## **OXFORDSHIRE COUNTY COUNCIL'S RESPONSE TO CONSULTATION ON THE FOLLOWING DEVELOPMENT PROPOSAL**

**Application no:** 23/01493/REM

**Proposal:** Reserved Matters Application including access, layout, landscaping and scale pursuant to outline planning permission 14/02121/OUT for internal primary and secondary streets along with the partial discharge of conditions 12 (Building for Life 12), 16 (means of vehicular access), 17 (means of pedestrian/cycle links) and 19 (detailed surface water drainage scheme) for Phase 1B

**Location:** Proposed Himley Village North West Bicester, Middleton Stoney Road, Bicester

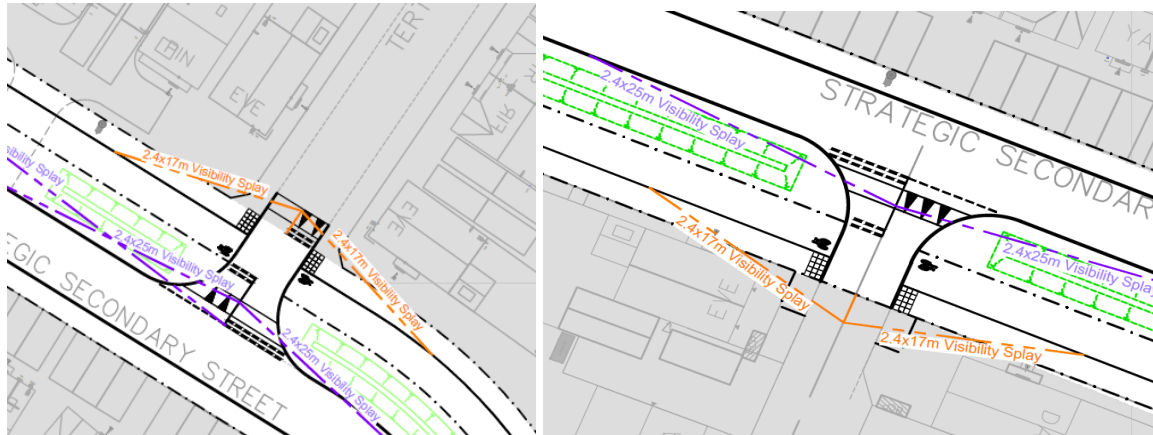
The red line boundary on the visibility splay drawings is still incorrect and needs to be amended.

It was noted that some visibility splays are located outside the red line boundary (see below). All visibility splays need to be within the red line boundary.

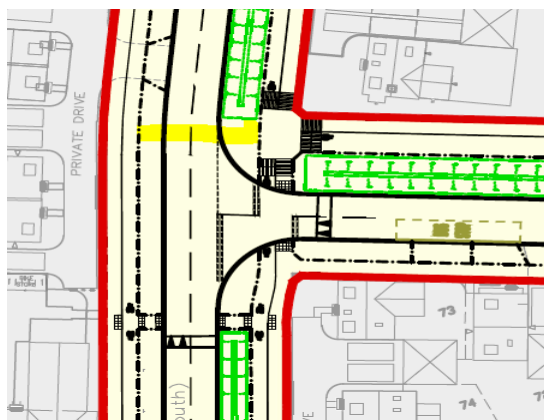
There are some areas of land for visibility that appear to fall outside of the highway extent. All visibility splays and forward visibility splays should be clear from obstruction and would be required for adoption if the roads are to be entered into a S38 agreement.

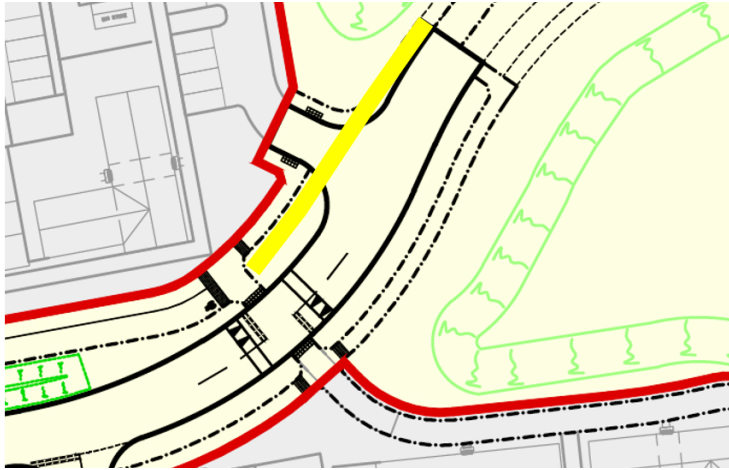
The cycle crossing over the Spine Road North -South to connect to the Spine Road East-West has not been included. We suggest that a crossing is included at the location in yellow below.

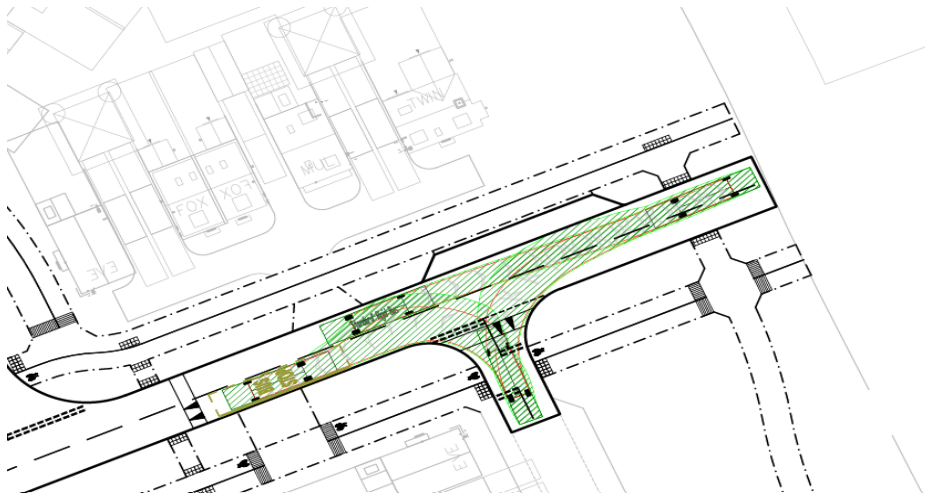
A raised cycle priority crossing is required at the eastern end of the Spine Road East-West for cyclists to be able to access the next phase of the development.

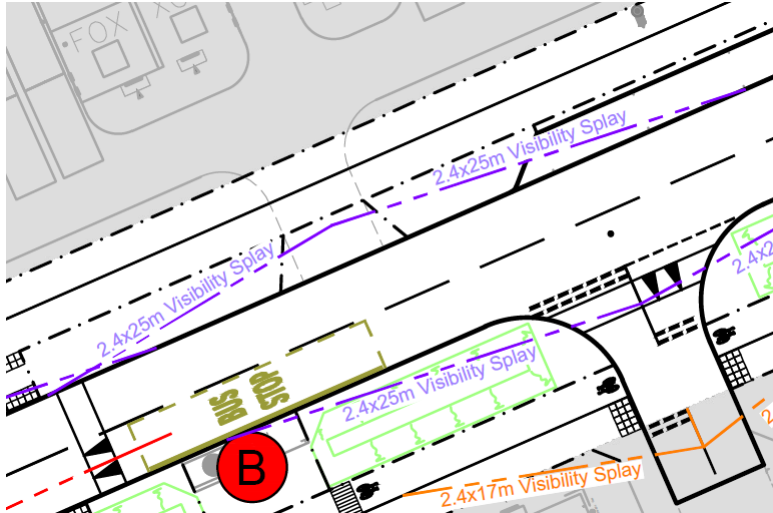
The temporary bus turning heads are not acceptable as it will require buses reversing over the raised cycle crossings which is considered a safety issue. In addition, all wheels will need to face forward and not be at an angle at the turn. Specifically designated independent turning heads should be constructed for buses to be able to turn.

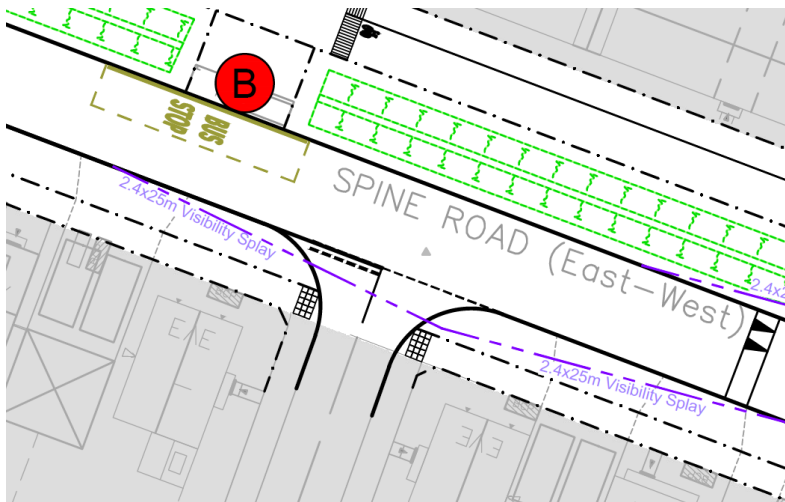
The visibility crosses the bus shelter on the Spine Road North- South. Visibility splays should be clear of obstruction.

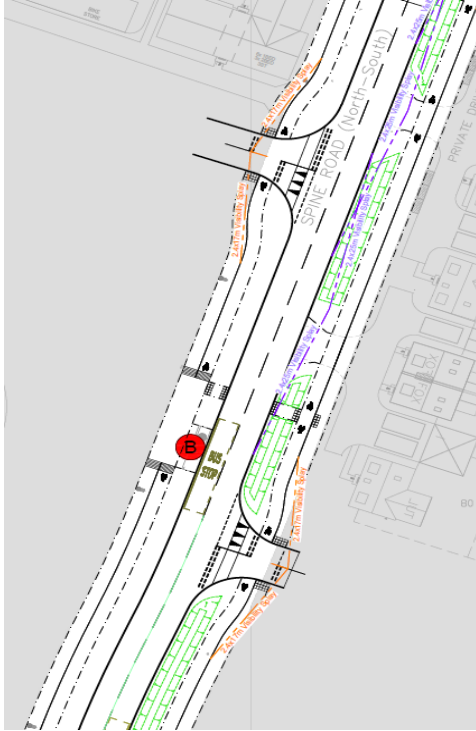
At a number of locations, the visibility splays do not commence in the centre of the side road and are therefore in the incorrect location.
